SUBJECT: QUAD CITIES NUCLEAR POWER STATION, UNITS 1 AND 2 - STAFF ASSESSMENT OF INFORMATION PROVIDED PURSUANT TO TITLE 10 OF THE *CODE OF FEDERAL REGULATIONS* PART 50, SECTION 50.54(f), SEISMIC HAZARD REEVALUATIONS FOR RECOMMENDATION 2.1 OF THE NEAR-TERM TASK FORCE REVIEW OF INSIGHTS FROM THE FUKUSHIMA DAI-ICHI ACCIDENT (TAC NOS. MF3879 AND MF3880)

STAFF ASSESSMENT BY THE OFFICE OF NUCLEAR REACTOR REGULATION

RELATED TO SEISMIC HAZARD AND SCREENING REPORT

QUAD CITIES NUCLEAR POWER STATION, UNITS 1 AND 2

Figure 3.3-1 Plot of Staff's and Licensee's Base Case Shear-Wave Velocity Profiles for the Quad Cities Site

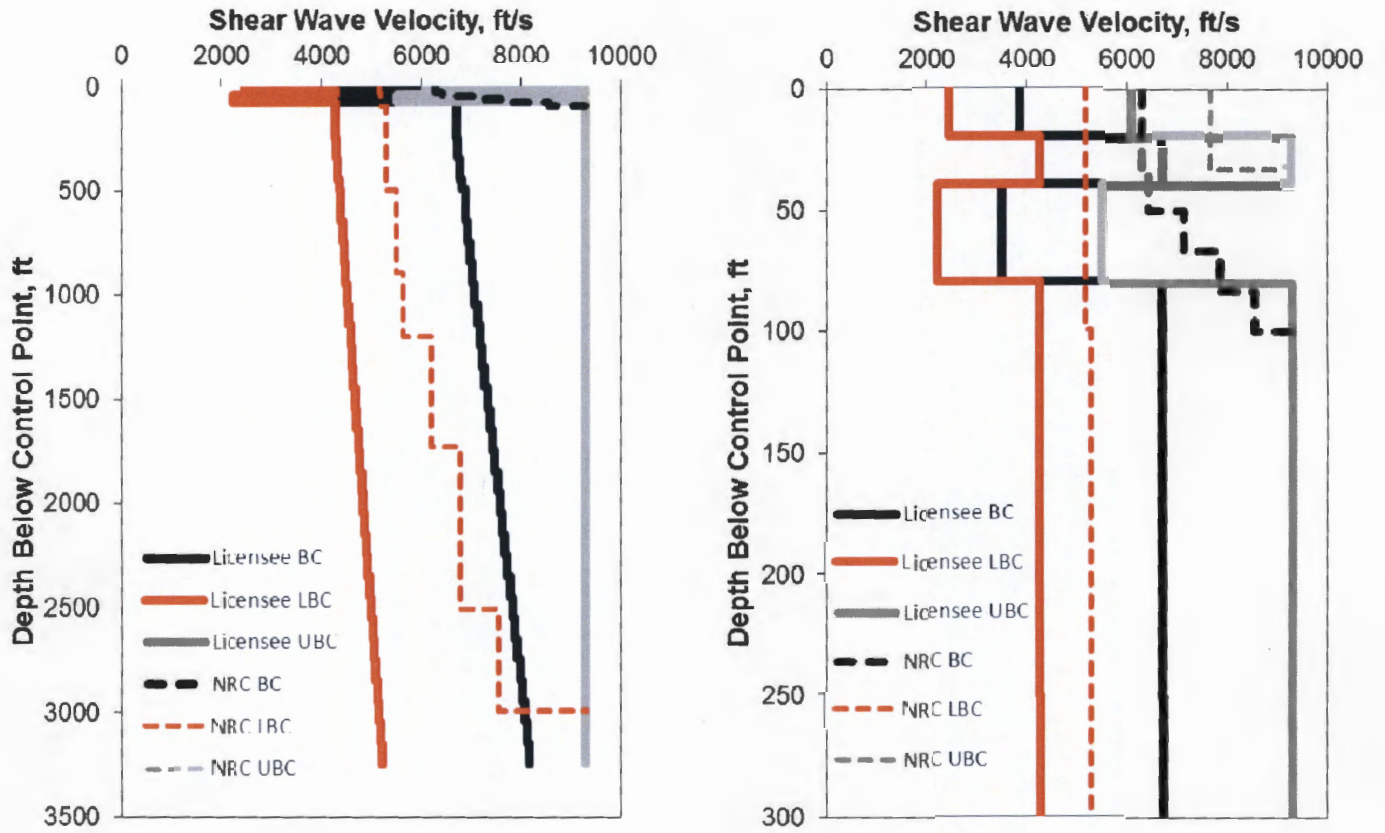
To perform its confirmatory analysis, the NRC staff utilized information from the Quad Cities Plant Design Analysis Report (PDAR) to estimate the near surface shear wave velocity of the dolomite from the Sulirian Niagaran Formation. Because the estimated near surface shear wave velocity is in the lower range for typical dolomites, NRC staff applied judgement in estimating the lower base case shear wave velocity. The upper base case velocity was estimated using a scale factor of 1.2, corresponding to a natural log standard deviation of 0.15. The NRC staff used the template velocity profiles from the SPID to estimate the shear wave velocities for the deeper layers. Figure 3.3-1 shows a comparison of the licensee's and staff's three base case velocity profiles. As shown in Figure 3.3-1, the staff's profiles are generally higher than the licensee's and do not include the licensee's low velocity zone between 50 and 75 ft (15 and 23 m). The reason for the difference is that the NRC staff relied primarily on the representative dolomitic bedrock properties in Table II-5-2 of the PDAR to characterize the near surface shear wave velocity. As such, the staff's three velocity profiles are generally higher than those estimated by the licensee. In contrast, the licensee appears to have assigned lower velocities to the soft solution-riddled zones between 50 and 75 ft (15 and 23 m). However, these dolomites beneath the plant were grouted prior to construction of the plant and likely now have somewhat higher shear wave velocities.

This difference is due to the differences between the staff's and licensee's near surface shear wave velocity profiles in the upper 50 to 75 ft (15 to 23 m). As shown in Figure 3.3-3, these differences do not substantially impact the lower frequency control point hazard curves, which are very similar. However, the staff's PGA control point hazard curve is moderately higher than the licensee's curve due to the differences in the best estimate base case and upper base case velocity profiles.

Figure 3.3- 1 Plot Comparing the Staff's and the Licensee's Median Amplification Functions and Uncertainties for the Quad Cities site.

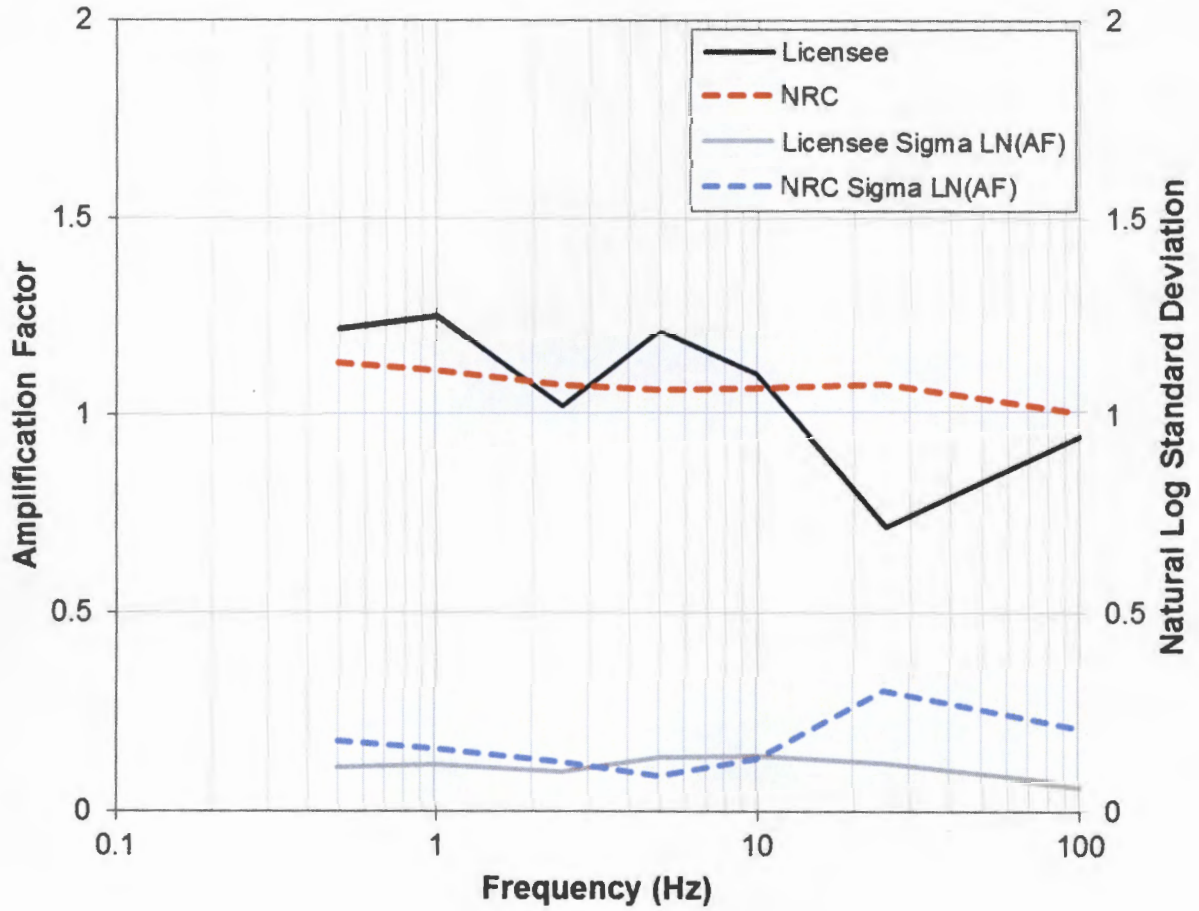
Figure 3.3-2 of this assessment shows a comparison of the staff's and licensee's median site amplification functions and uncertainties for the input loading level of 0.05 g. The licensee's and staff's amplification functions are similar with moderate differences in amplification at 25 Hz.

Figure 3.4-1 Comparison of the Staff's GMRS with Licensee's GMRS and the SSE for the Quad Cities site

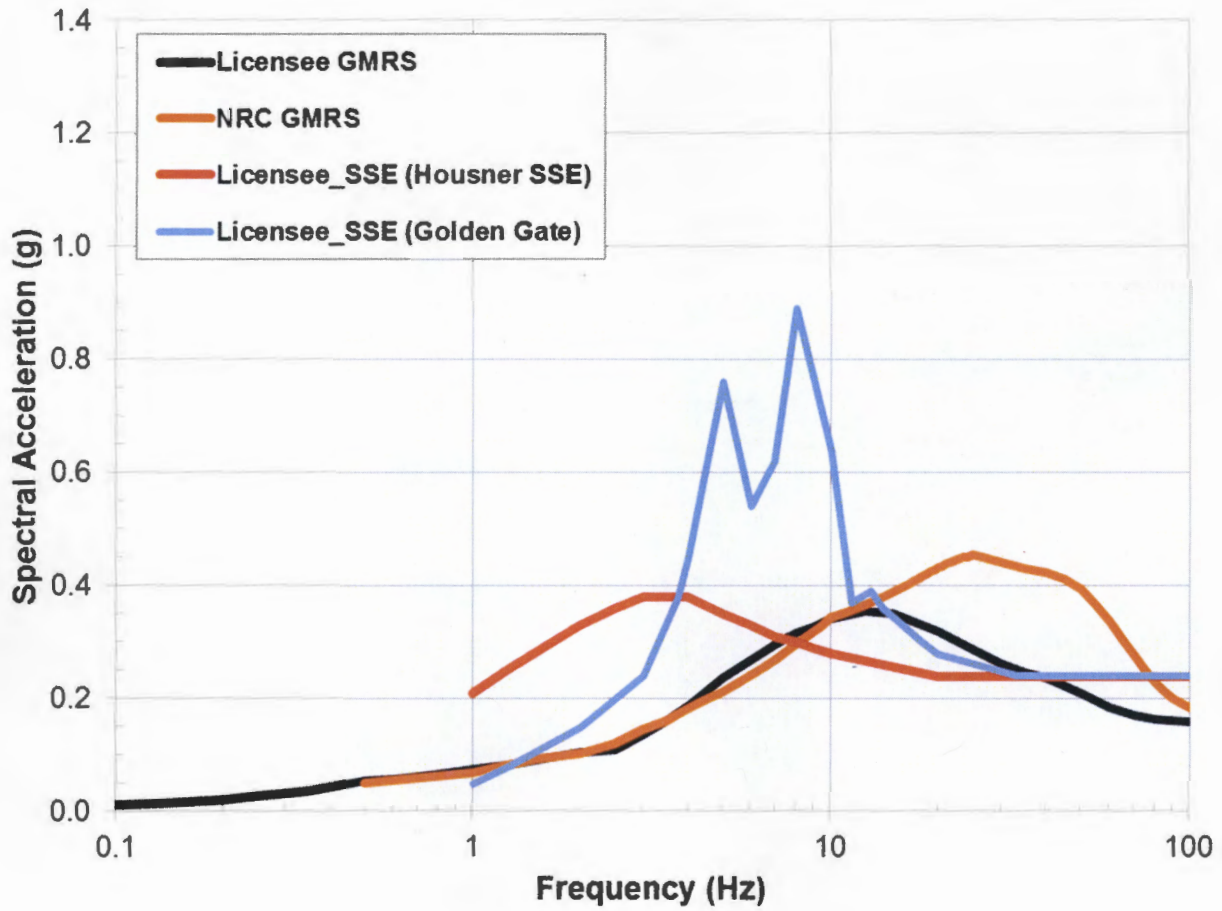
The NRC staff independently calculated the 10^{-4} and 10^{-5} UHRS using the results of its confirmatory PSHA and site response analysis, as described in Sections 3.2 and 3.3 of this staff assessment, respectively. Figure 3.4-1 of this assessment shows a comparison of the GMRS determined by the licensee to that determined by the NRC staff.

As shown in Figure 3.4-1 below, the licensee's GMRS shape is generally similar to that calculated by the NRC staff up to 10 Hz. At frequencies above 10 Hz, the GMRS determined by the licensee is lower from that determined by the NRC staff. As described above, these differences in GMRS are the result of differences in the site response analyses performed by the licensee and NRC staff as discussed in Section 3.3 above. The NRC staff concludes that these differences are acceptable for this application because the licensee followed the guidance provided in the SPID with respect to both the PSHA and site response analysis for the Quad Cities site.

The NRC staff confirms that the licensee used the present-day guidance and methodology outlined in RG 1.208 and the SPID to calculate the horizontal GMRS, as requested in the 50.54(f) letter. The NRC staff performed both a PSHA and site response confirmatory analysis and achieved results consistent with the licensee's horizontal GMRS. As such, the NRC staff

concludes that the GMRS determined by the licensee adequately characterizes the reevaluated hazard for the Quad Cities site. Therefore, this GMRS is suitable for use in subsequent evaluations and confirmations, as needed, for the licensee's response to the 50.54(f) letter.
